SERVICE BULLETIN

APL-SB18

Applicability: Propeller Models: ALL AP332S models with steel retention components manufactured up to Nov 2019

SUBJECT: GREASE SEEPAGE FROM RETENTION NUT SEAL

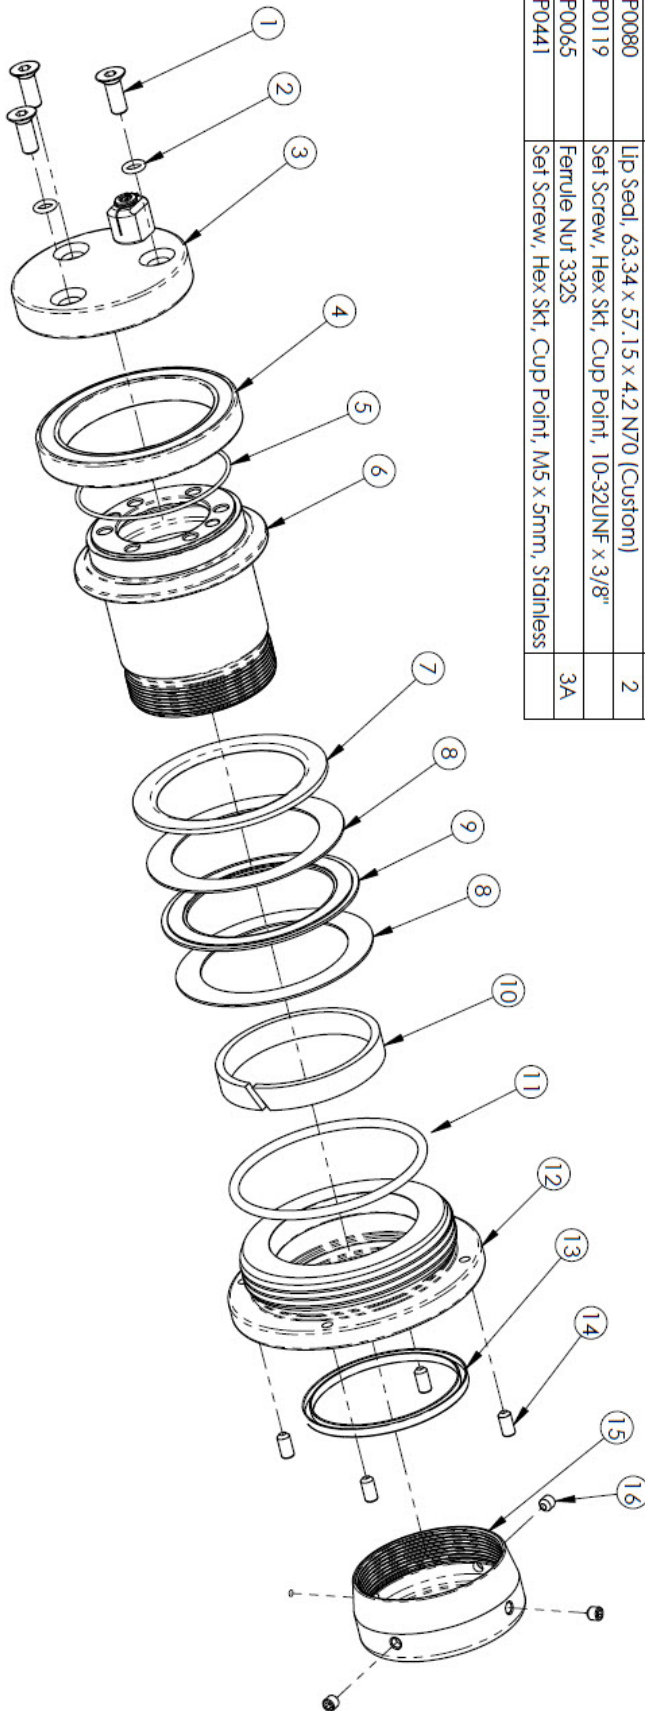
1. The o-ring (P0194) sealing between the retention nut and the hub can be replaced with one that is slightly larger (P0414-232). The increased interference from the larger o-ring will form an effective seal.

2. The thrust bearing spacer (P0047) can be upgraded to the next revision of this part (P0047 r1A -> P0047 r2). The thinner section of the new part will allow the retention nut to seat more deeply in the hub bore and allow the existing seal to reach its proper engagement.

- a. Return the completed compliance record to Airmaster propellers for our records
- b. Insert the updated BOM (see below) into the propeller file
- c. Record the new installation torque (15Nm) into the operators handbook
- d. Monitor propeller for grease leaks during normal pre-flight inspection
